American Certification Body Inc.  
6731 Whittier Ave, C110, McLean, VA 22101

RE: Rondish Company Limited  
FCC ID: WNG-DMS-02  
IC: N/A  
ATCB021173

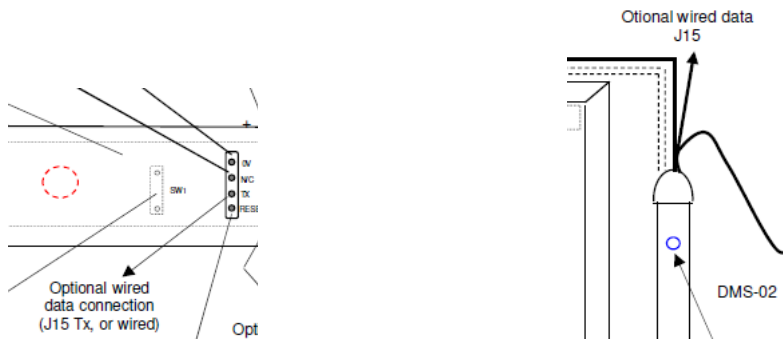
- 1) The User Manual exhibit (page 6 of 22) appears to indicate the DMS-02 transmits a signal to a partner DMS-02 sensor when an alarm is activated:

**Note:** When more than one sensor strip is used on a door, when an alarm is activated a wireless signal is automatically sent to activate its partner sensor strip having the same door ID code. This ensures that both monitors activate when protecting the same door, or area.

Please clarify if the DMS-02 unit has a transmitter.

**0614: no transmitter for DMS-02, the manual has been revised and uploaded.**
